# AGENDA

## February 16, 2023 Standards Committee Meeting

RE: Agenda for the February 16, 2023 Standards Committee Meeting

E 809-ITCS-01 ITS TRAFFIC COUNT STATIONS INDEX AND GENERAL NOTES (proposed draft)

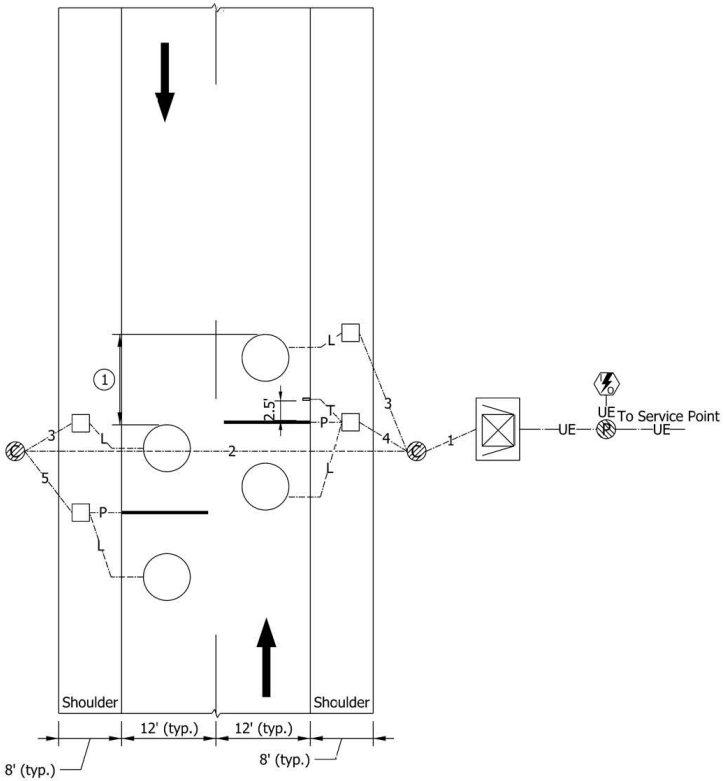
PROBLEM(S) ENCOUNTERED: The ITS traffic count station (unique) plan details for automated traffic recording, weigh-in-motion, and virtual weigh-in-motion locations were initially prepared in Microsoft PowerPoint and there is a need to update the formatting so that they can be issued as Standard Drawings.

PROPOSED SOLUTION: Create a Standard Drawing series for the ITS traffic count stations for automated traffic recording, weigh-in-motion, and virtual weigh-in-motion locations.

E 604-SWCR-11 MEDIAN CUT-THROUGH AND MEDIAN PERPENDICULAR CURB RAMP TYPICAL PLACEMENT (with shown markups)

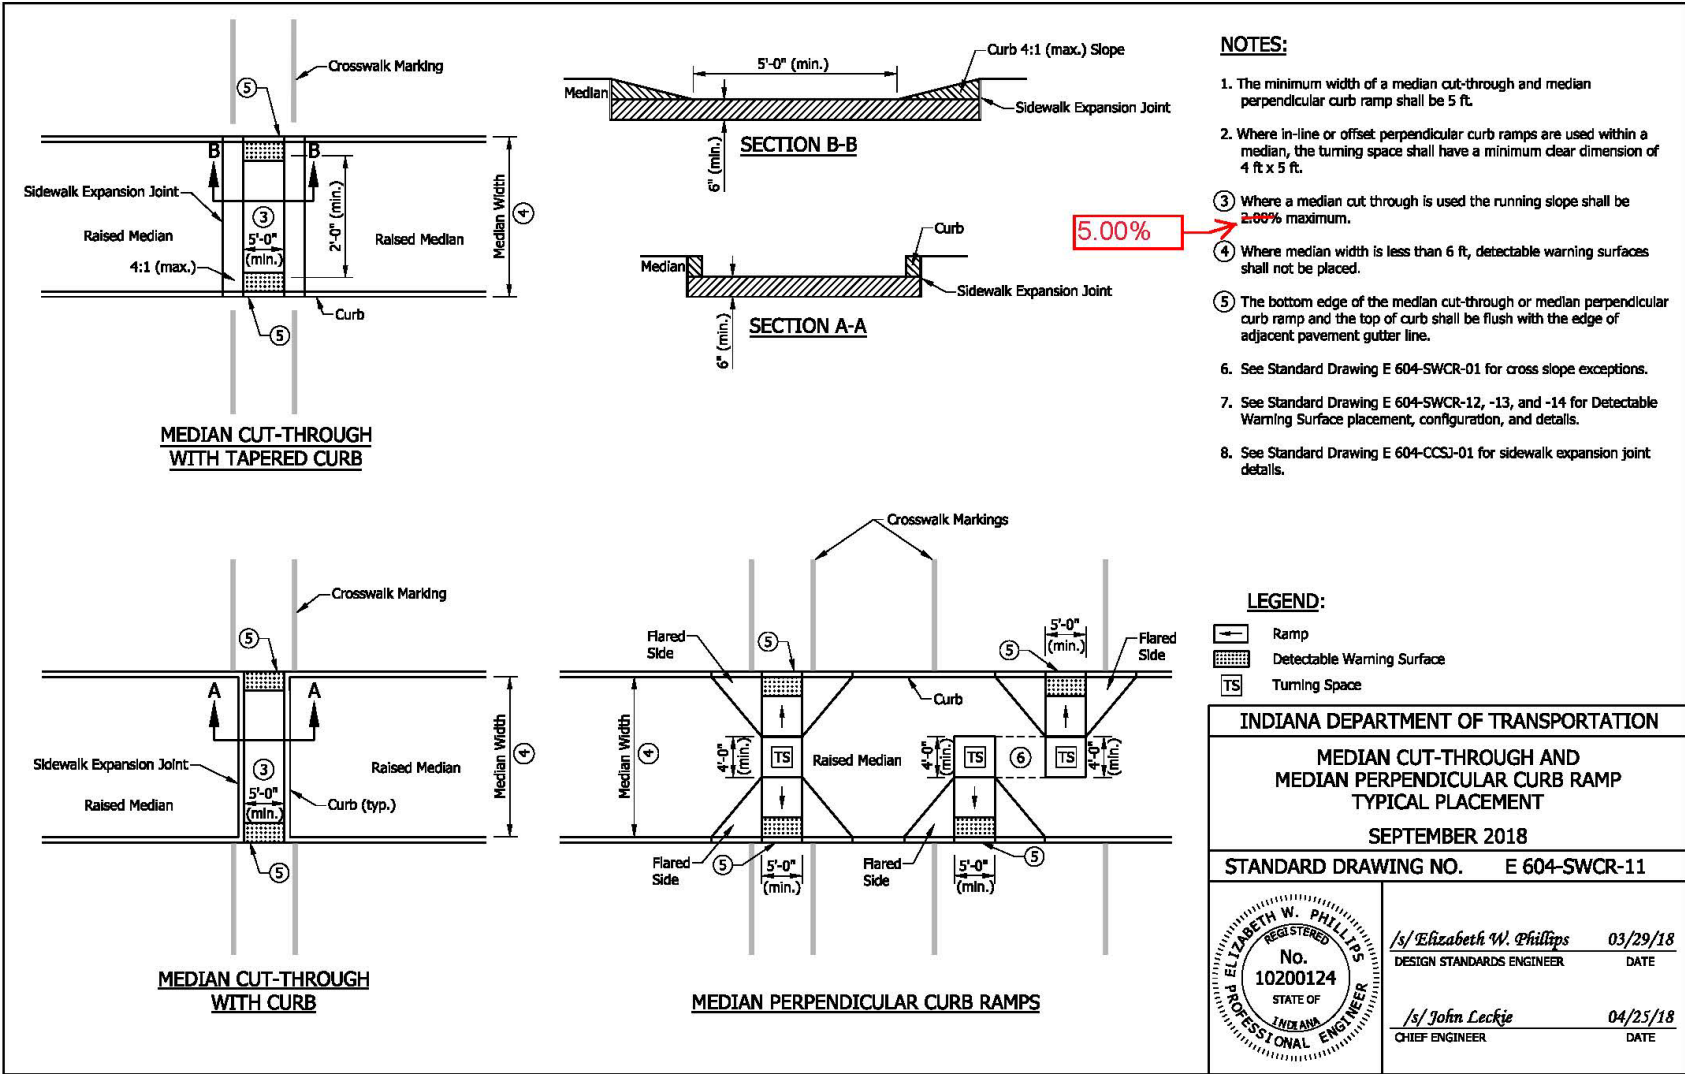
PROBLEM(S) ENCOUNTERED: Standard Drawing series 604-SWCR. Standard Drawing 604-SWCR-11, note 3, limits the running slope of a median cut-through to 2%. Upon further review of the Proposed Right-of-Way Accessibility Guidelines (PROWAG) and clarification from the US Access Board, the running slope may be a maximum of 5%. Given the geometry of divided highways and intersections, the increase of the maximum running slope will allow for more flexibility in design. Standard Drawing 604-SWCR-13, there has been some confusion on the offset of a detectable warning surface from a railroad crossing. The current drawing only takes into account a perpendicular crossing of a sidewalk, where many crossings are at a skew. When a railroad crosses a sidewalk at a skew, the designer and contractor must take into account the minimum and maximums within the Public Rights-of-Way Accessibility Guidelines (PROWAG) and the location of the railroad dynamic envelope.

PROPOSED SOLUTION: Standard Drawing 604-SWCR-11, change note 3 to state, where a median cut-through is used the running slope shall be 5.00% maximum. Standard Drawing 604-SWCR-13, add a skewed railroad crossing detail, add dynamic envelope lines to both railroad crossing details, modify note 4 to define the dynamic envelope location, and add a note to give the minimum and maximum offset of a detectable warning surface in relationship to the dynamic envelope and the nearest rail.
